RECEIPT DATE: 3/25/2022 **ONSITE SEWAGE DISPOSAL SYSTEM**

APPROVAL DATE: 4/12/2022 **PERMIT: CONSTRUCTION**

PROPERTY ADDRESS: 8030 Kayladine Lane

SUBDIVISION: Dustin Golden Fields

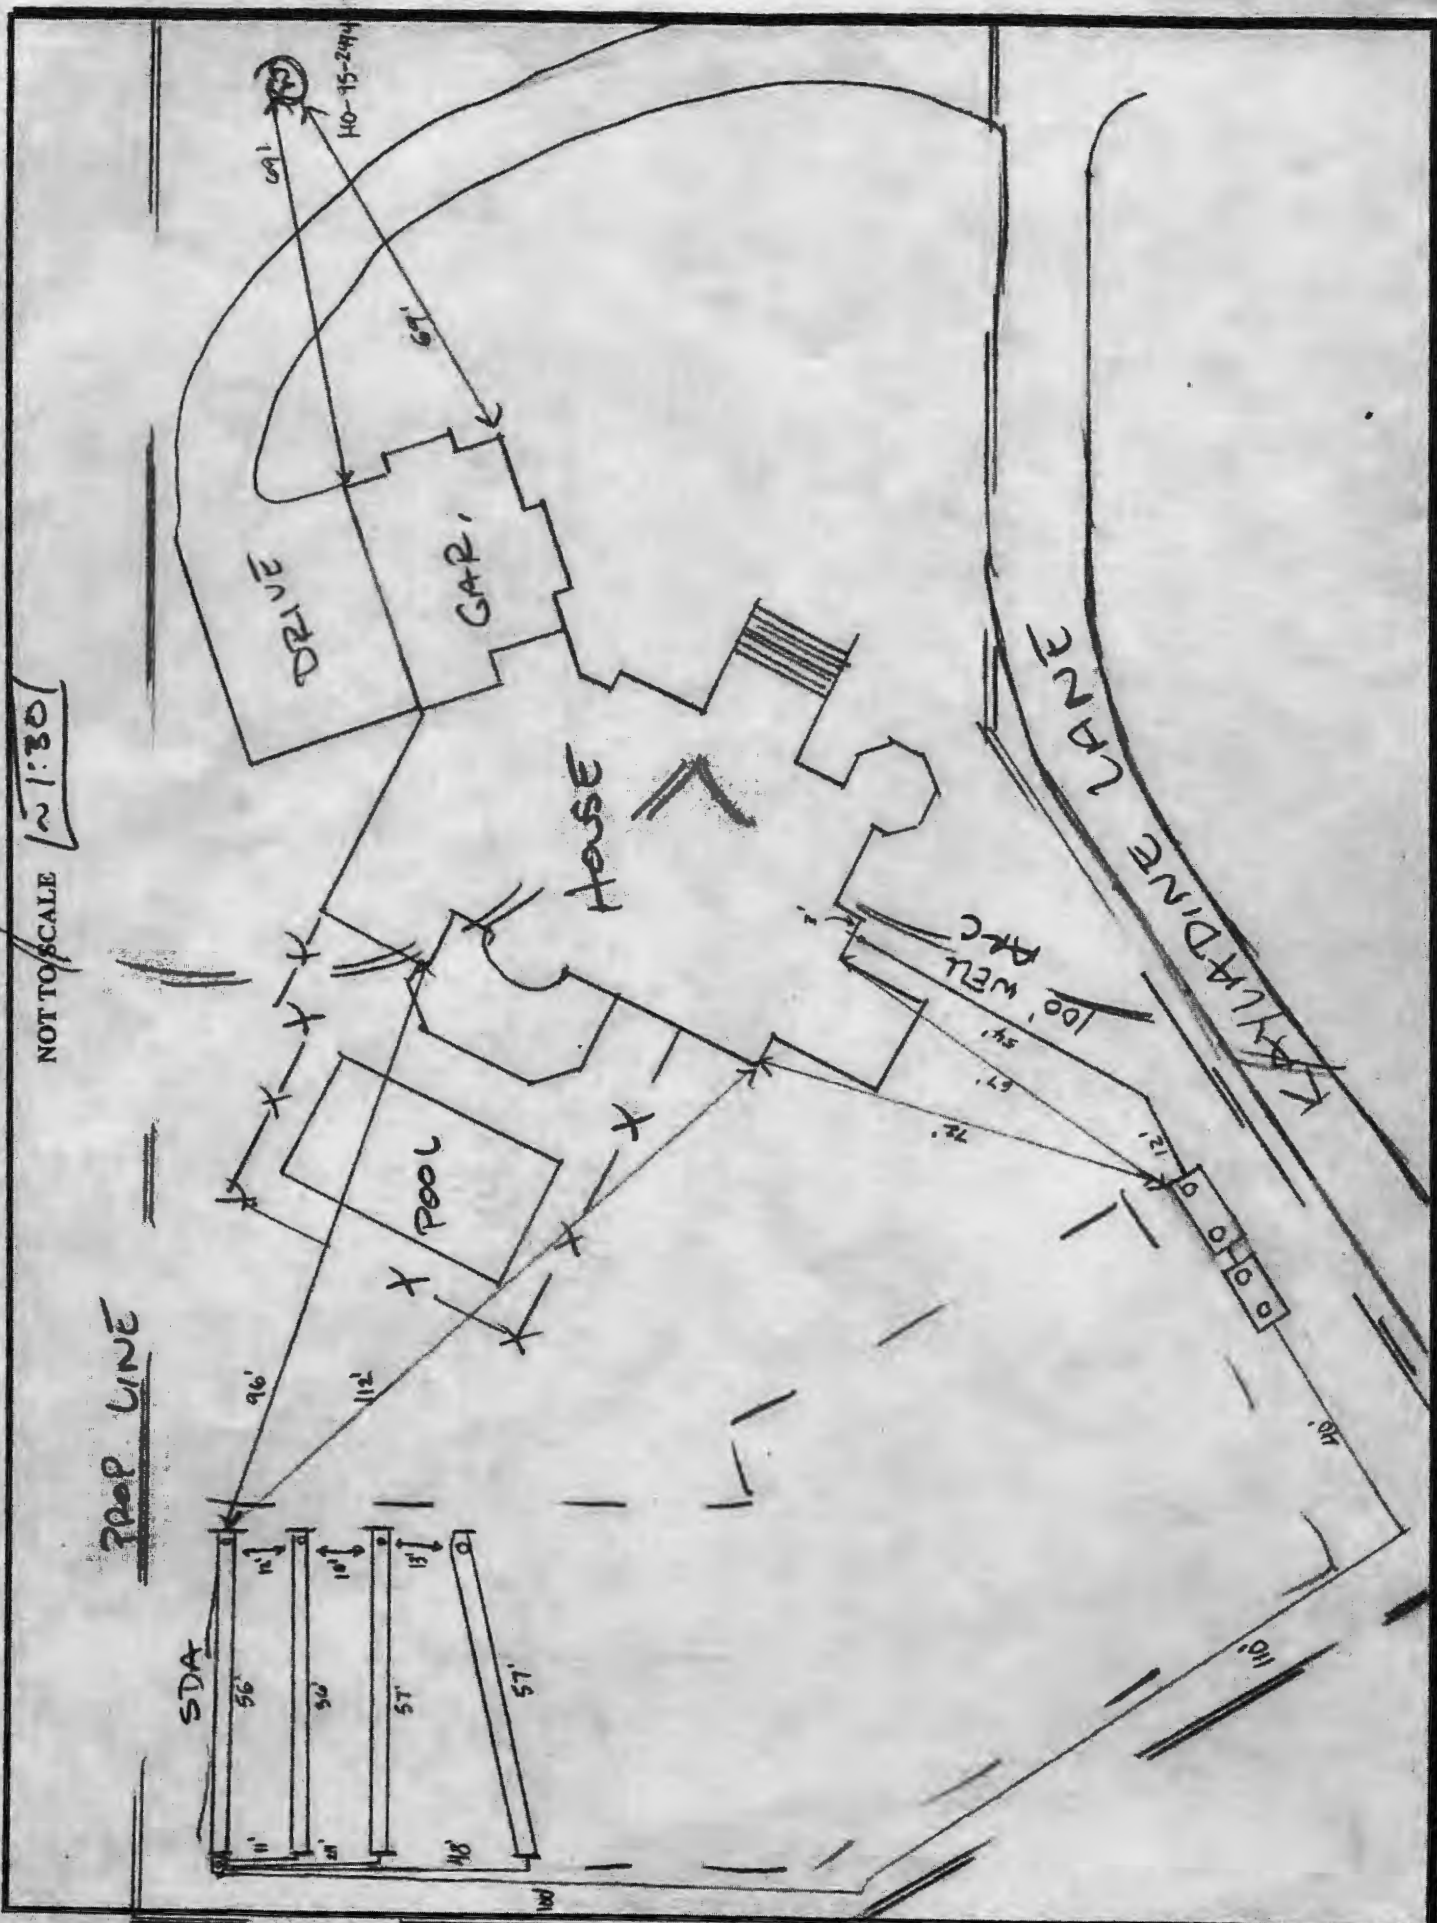
04/08/2022 CONFIRMED 4x55' TRS ON CONTOUR. (P)

INSTALLATION: 9/14/22 4x56' trenches installed. D-box set (P) 4/18/22 SHC and SL constructed Tanks set. FM installed (see photos attached. Work done on holiday) Re-insp for P+A. (SD) 9/1/23 - P+A ok - builder installed a man made swale over top of the existing new trenches and some more of the SOA where the 1st & 2nd systems are to be installed. KW spoke to builder, swale must be removed. 9/13/23 - site inspection to see if man made swale was removed, but it was still there in the same location on top of the trenches and it seemed bigger. (P)

9/15/2023 Issues w/ swale in SOA removed.

SHEET
SITE PLAN

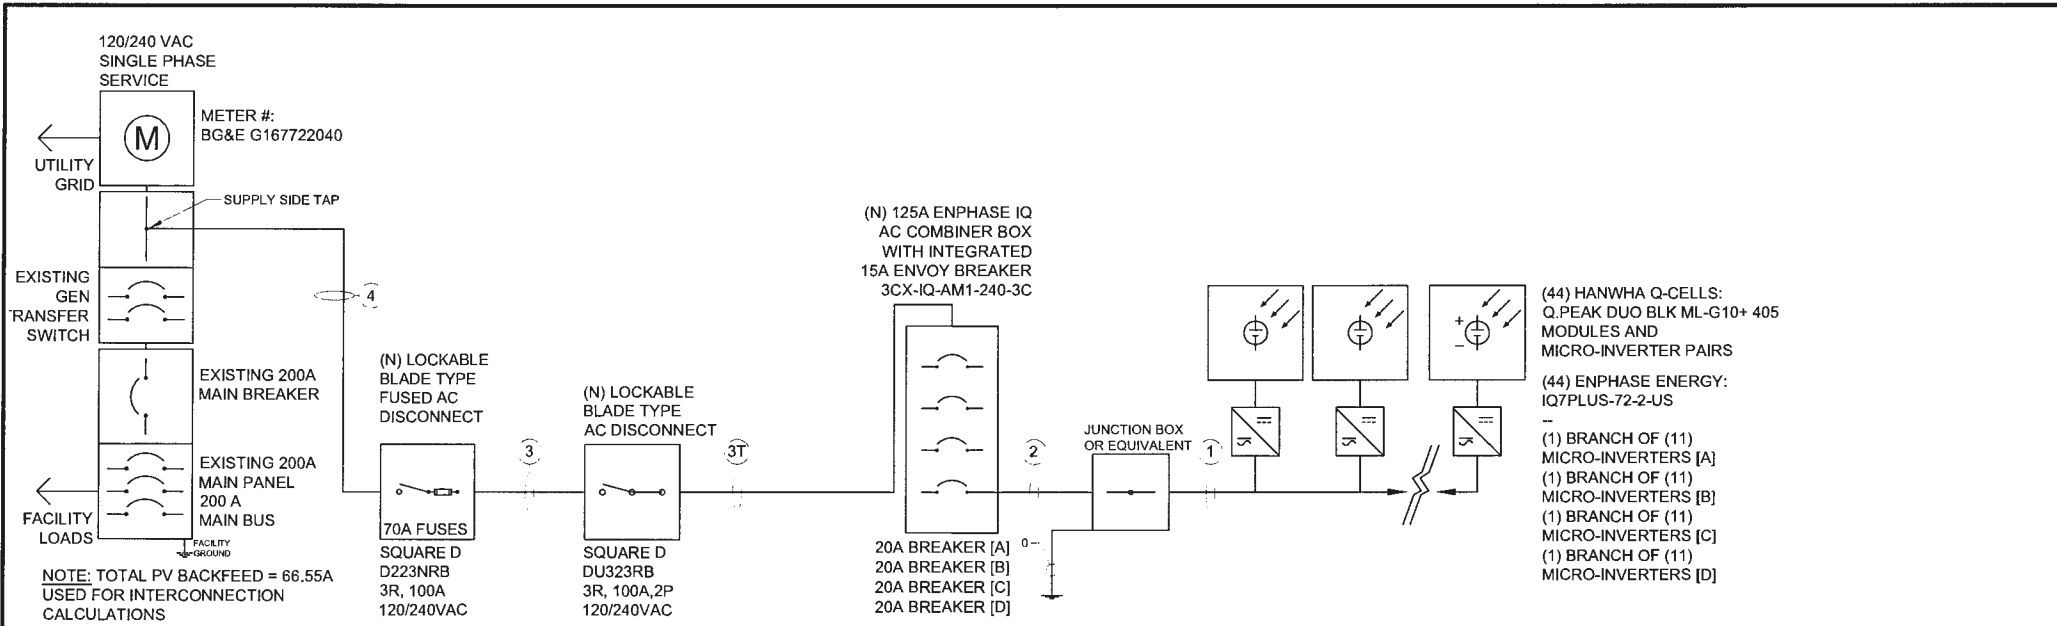
I, **Patrick Oguejiofor**, homeowner at 8030 Kayladine Ln, Fulton, MD, 20759. I'm writing this letter to ask for a waiver in needing to meet the required setback distance to the sewage disposal area to allow Sunrun Installation Services to complete the installation of ground mounted solar panels on my property mentioned above. This solar installation will be in an area that is at least the minimum 5ft. from the sewage disposal area and in a cleared area that is only reserved for a future septic system replacement and not the current septic system.

*approved
in location
shown in 1/16/24 site
plan. Saw 2/12/24*
